Subject: UNABLE TO ADJUST DRIVER-SIDE MANUAL SEAT LIFT	Bulletin No: 09-039/07
	Last Issued: 11/21/2007

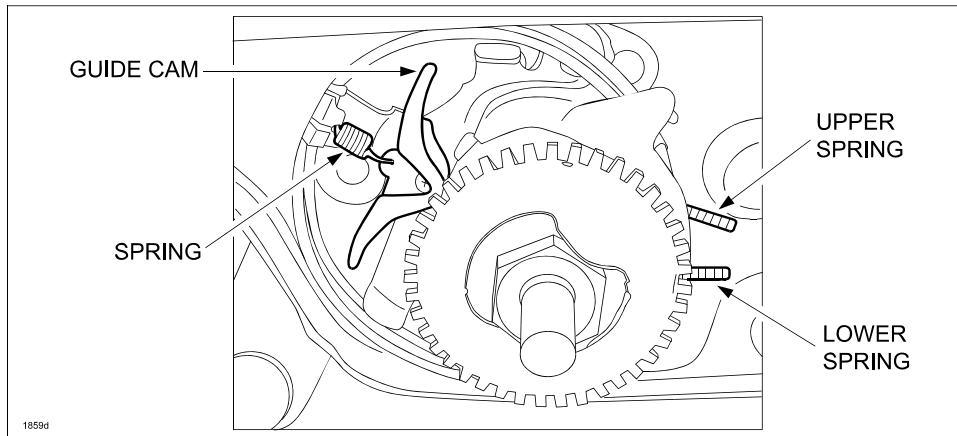
On some vehicles, the driver-side seat lift cannot be adjusted because the lock plate guide comes off the guide cam when operating the lift. If the lift lever is then operated with the lock plate guide off, the guide cam can be damaged. The shape of both ends of the guide cam has now been changed to stop the lock plate guide from coming off.

6. Replace the guide cam and spring with modified ones.
 - a. Remove the spring and pull the guide cam outward to remove it from the shaft.

- b. Apply grease to the guide cam shaft and the contact surfaces of the guide cam and lock plate hook by reusing grease from the old part.
 - c. Replace the guide cam and spring with the modified ones.

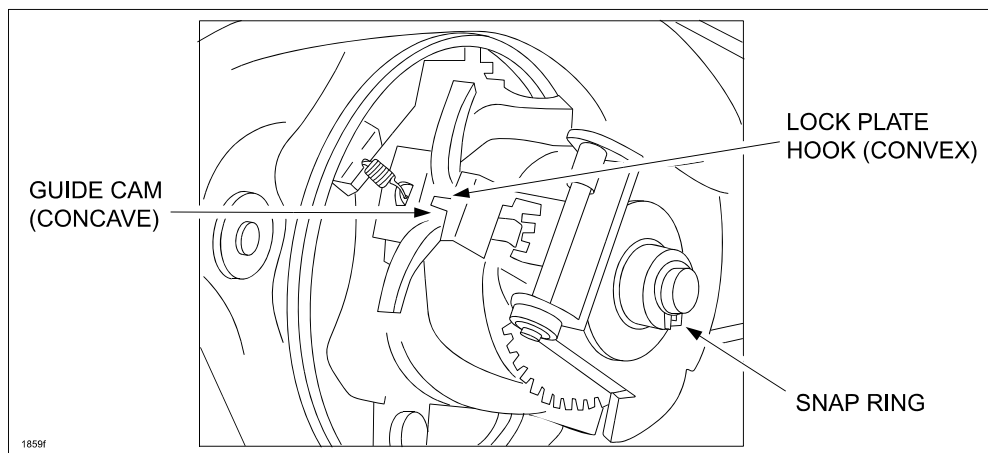
- c. Release finger from the moving part of the lock plate, then flip down the hook and allow it to engage with the gear.
- d. Make sure that the hook (convex) of the lock plate is fitted into the guide cam (concave).

NOTE: If the hook and guide cam are not fitted properly and the lift is operated, the guide cam will be damaged.
